PROJECT **Our Town Hall**

DRAWING TITLE **Eaves detail to NR02, NR06, SR09 and SR14. Lead flat roofs around courtyards**

DRAWING STATUS **S4 Construction**

DRAWING NO. **OTH-PUR-TH-RF-DWG-A-7003 09**

Eaves detail to roofs NR02, NR04, NR06, NR10, SR09, SR11 and SR14

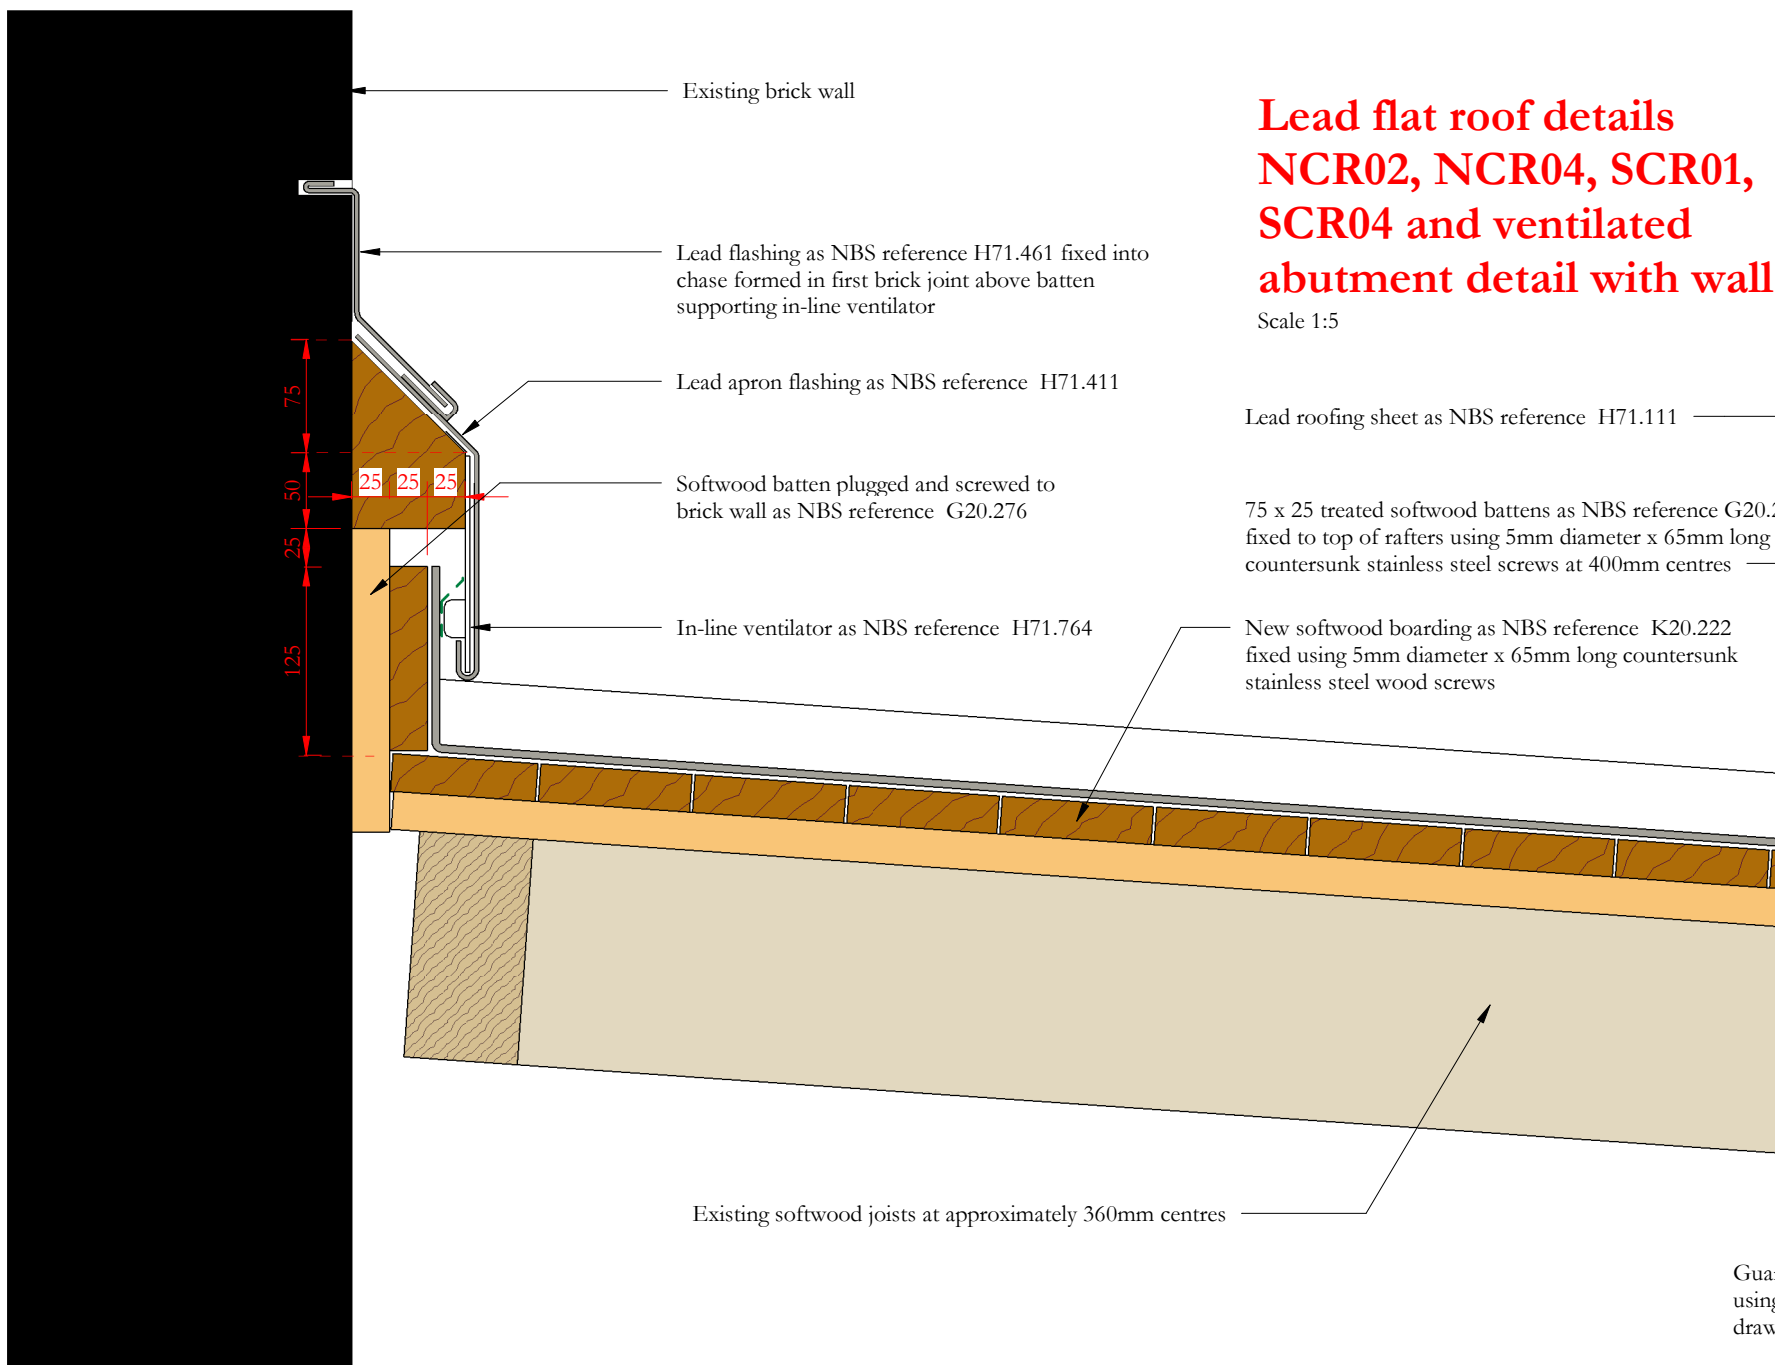
Revision 08: Softwood fascia omitted and substituted with 100 x 50mm noggins packed off beam with 44 x 44 x 50mm softwood packers

Revision 06: Size of packer between wall plate and cast iron gutter amended. Annotation regarding packer and gutter fixing amended

Revision 05: New treated softwood packer added between wallplate and back of gutter to accommodate the return ends to the cast iron gutter. Size of lead apron below gutter adjusted to fit over the new packer

Revision 04: Continuous stainless steel clip to apron flashing below cast iron gutter omitted. Apron flashing to cast iron gutter divided into two parts. Lower section running below gutter upper section dressed into gutter. Ventilator at junction of lead roof and upper slope of mansard roof changed to Airtrak VR 200

Lead flat roof details NCR02, NCR04, SCR01, SCR04 and ventilated abutment detail with wall

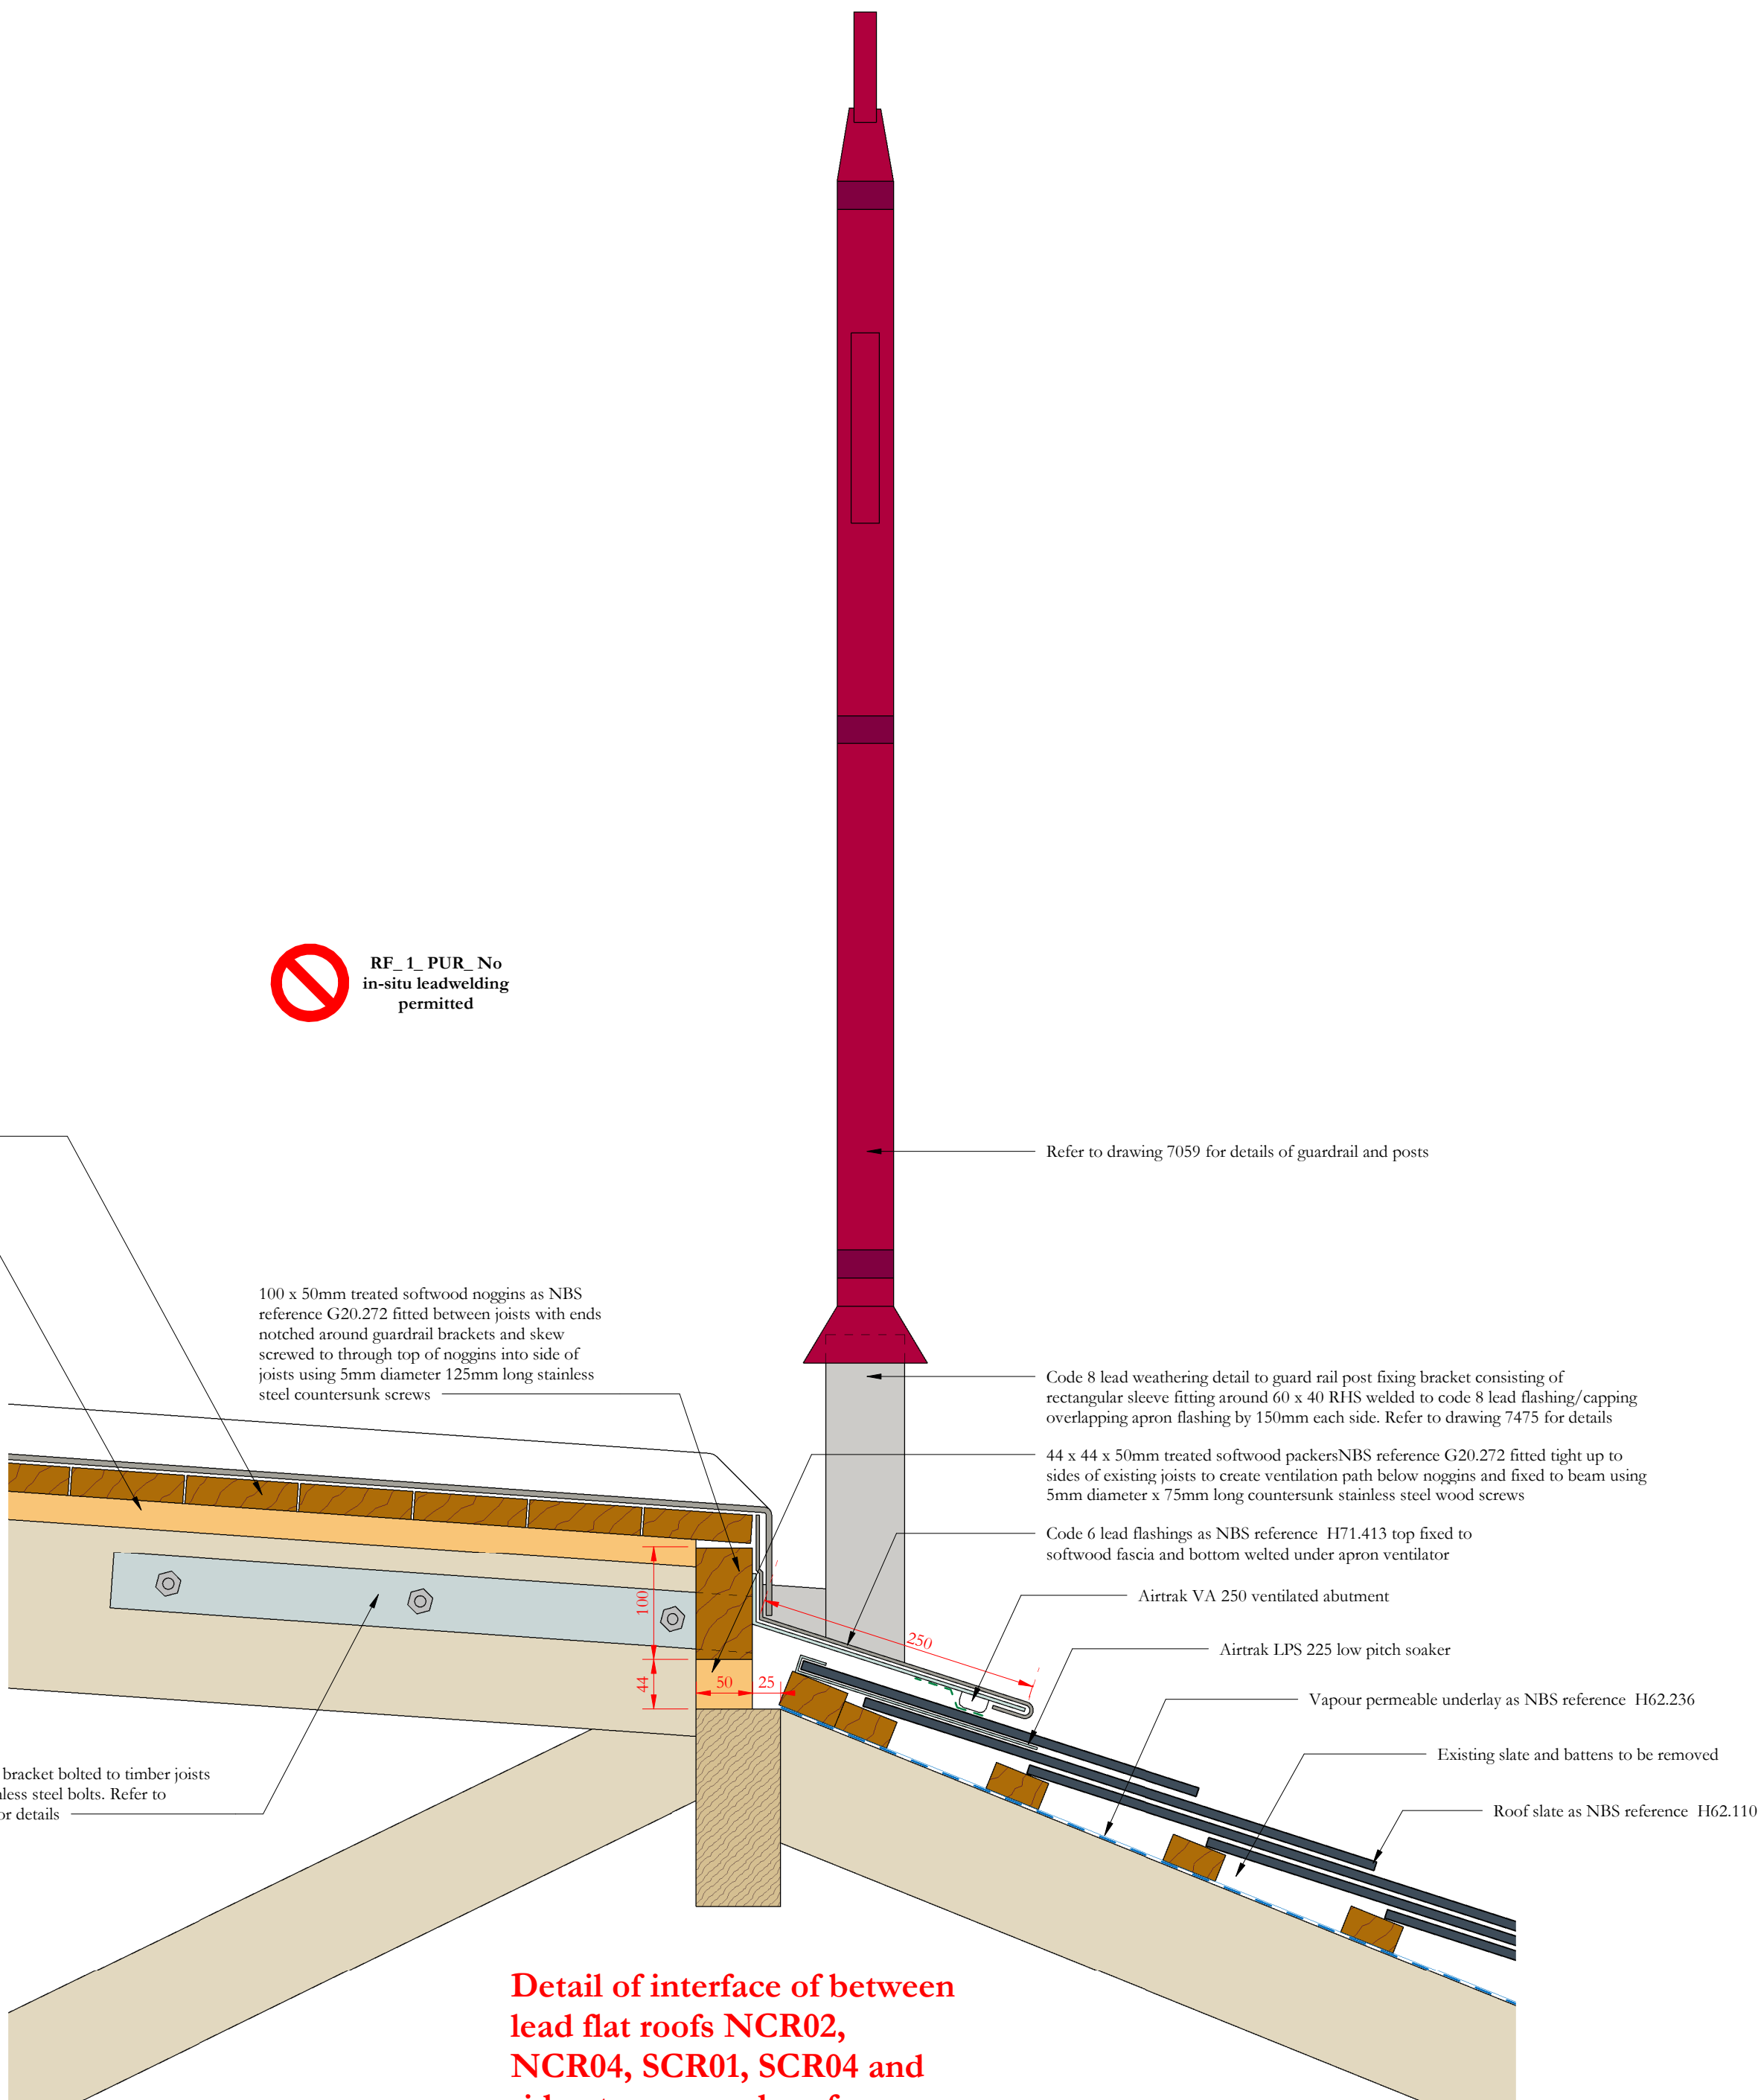
Revision 09: Ventilated abutment changed from Airtrak VA 200 to Airtrak VA 250 and Nicholsons Airtrak LPS 225 low pitch soaker added between top two slates

Revision 07: 75 x 25mm softwood batten shown fixed to top of roof joists to raise height of lead roof to accommodate sleeve detail to guardrails. Guardrail post and lead sleeve added
